**MAJOR PROJECT ASSESSMENT:
*Chris O'Brien Lifehouse at RPA
Bounded by Salisbury Road, Brown
Street, Missenden Road and Susan
Street, Camperdown, NSW
(MP10_0036)***

Director-General's
Environmental Assessment Report
Section 75I of the
Environmental Planning and Assessment Act 1979

December 2010

Figure 16: Height Comparison – Lifehouse vs. Page Chest (demolished) vs. St Andrews

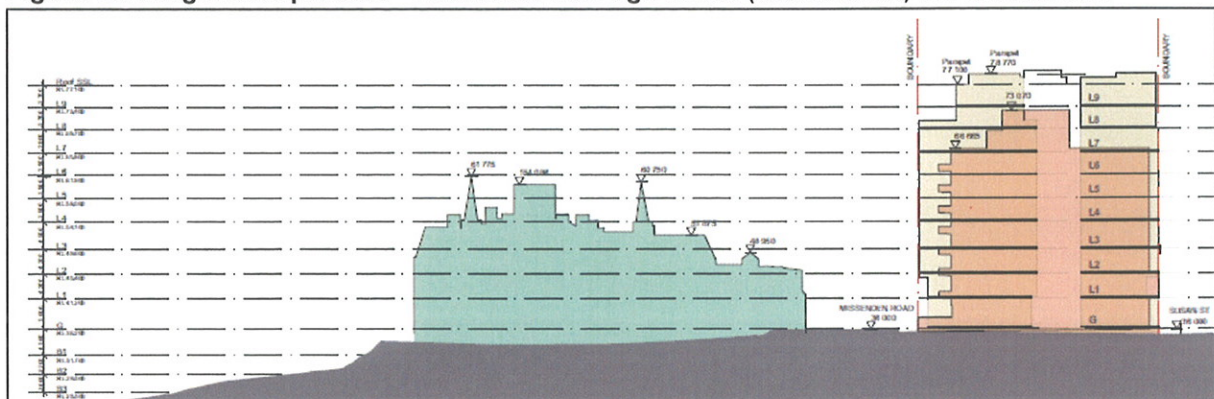
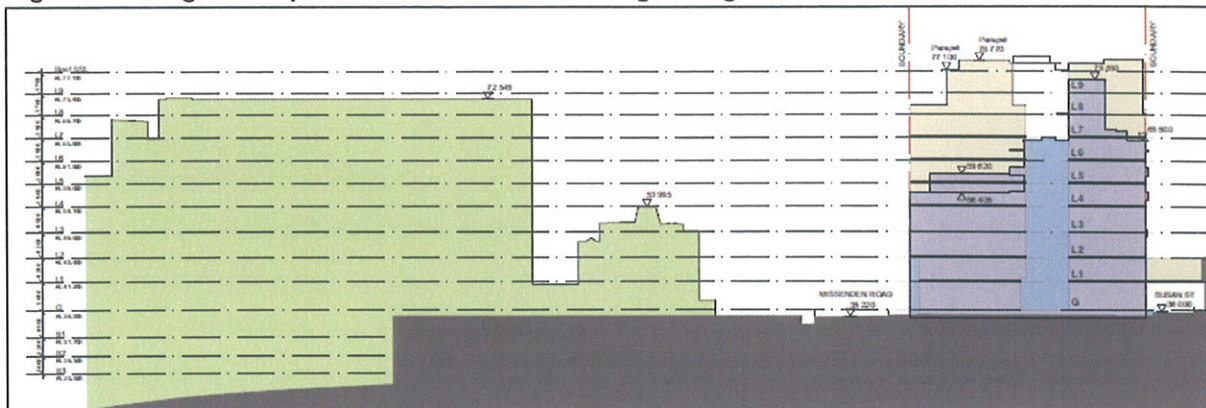
The proposed height and scale of the Lifehouse building was identified as a key issue by Council, noting that the height of the development should be reduced by one storey to be more consistent with the existing Page Chest Pavilion and existing buildings within the subject sites surroundings. Currently, the Chris O'Brien Lifehouse development is proposed to be two storeys higher than that of the existing Page Chest Pavilion and three storeys higher than the adjoining King George V Memorial Hospital.

It is evident from the existing built environment that a consistent building height within the RPA Hospital Precinct and surroundings has not been established. Further, the height of the adjoining King George V Memorial Hospital includes a large services tower that extends the perceived height of the building to approximately nine storeys (see Figures 17 & 18). Further, the existing Administration Building and Victoria and Albert Pavilions are provided with generous setbacks from Missenden Road, reducing their contribution to the street wall, similar to that of other development along Missenden Road. In this respect, it can be concluded that the existing street wall height of seven to eight storeys was only established by the previous Page Chest Pavilion and adjoining King George V Memorial Hospital.

Figure 26: Winter Solstice 3:00pm

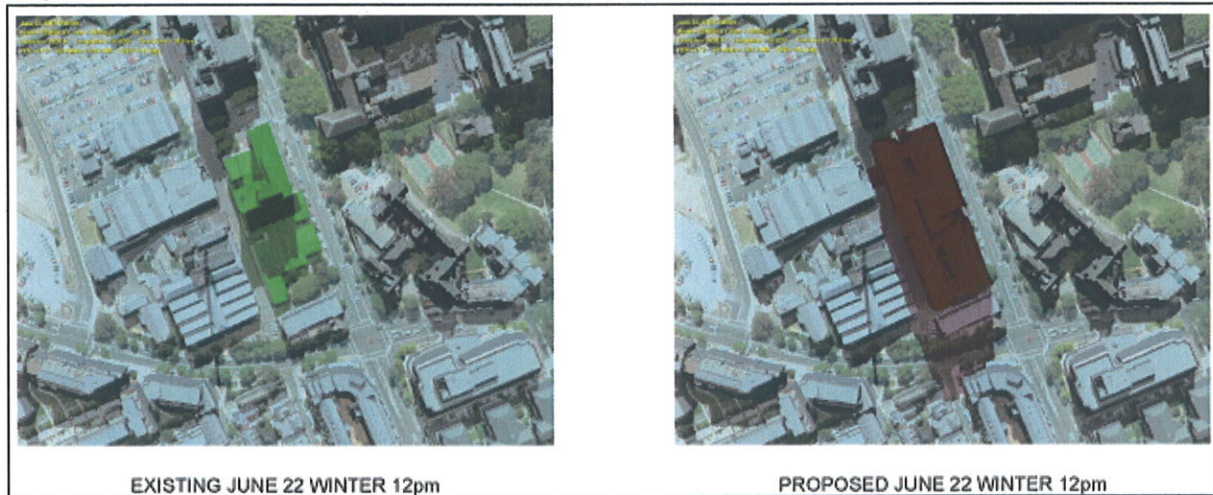
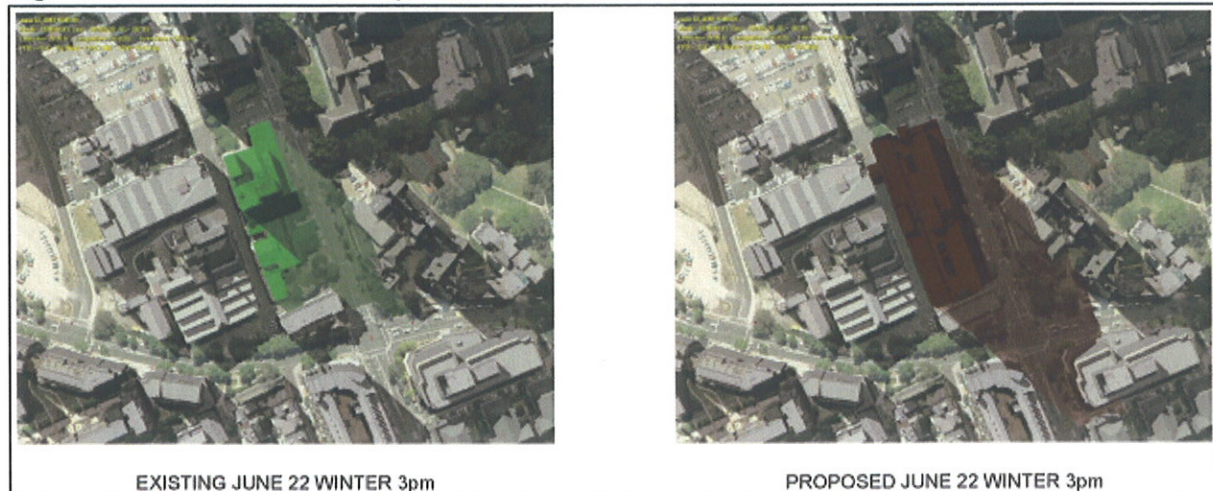
During the 9:00am winter solstice, an existing block of residential apartments on the south-western side of Carillon Avenue will experience additional minor overshadowing, however, a minimum of four hours of sunlight during the winter solstice is retained. Beyond 9:00am, impacts on the property will significantly reduce.

The shadowing impacts cast initially at 9:00am are further reduced by the Lifehouse building's north-south orientation, which reduces the width and cover of shadow cast as the azimuth of the sun moves during the day.

Figure 28: Medium Rigid Vehicle Turning Path

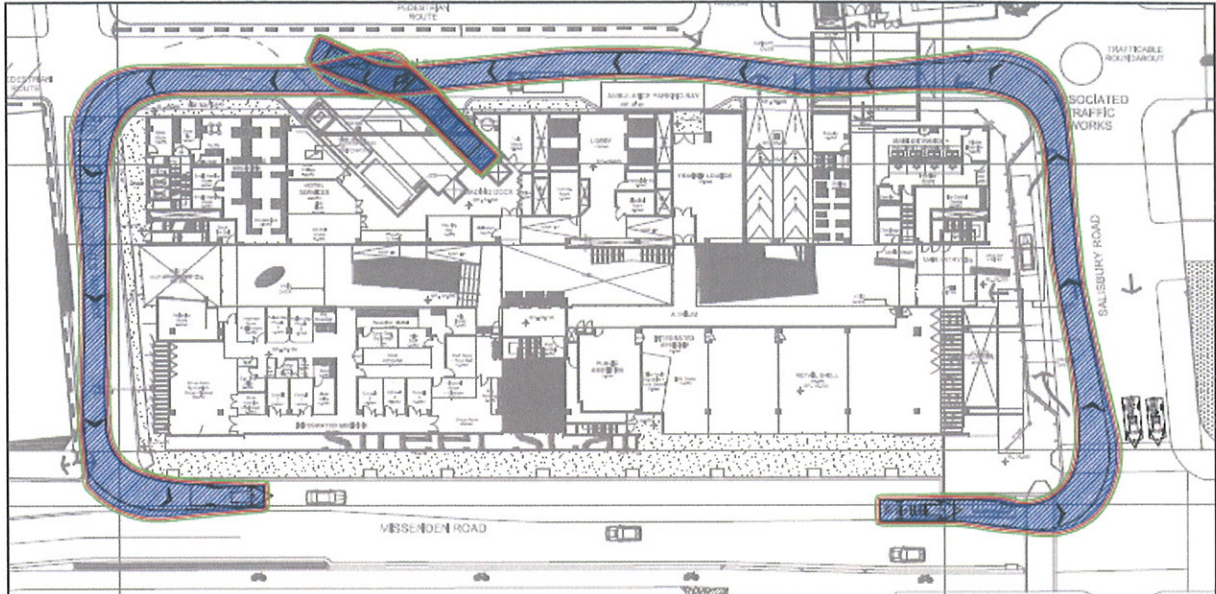
General concerns were raised by the City of Sydney Council and the RTA in relation to the provision of adequate space for vehicle manoeuvres, specifically at the rear of the site within the location of the proposed loading docks. In response, the Proponent provided updated

The Department considers that adequate provisions for access to the development have been provided. Furthermore, the Proponent has provided a number of commitments, ensuring that the site can be serviced and will not generate adverse impacts on general traffic movements around the development.
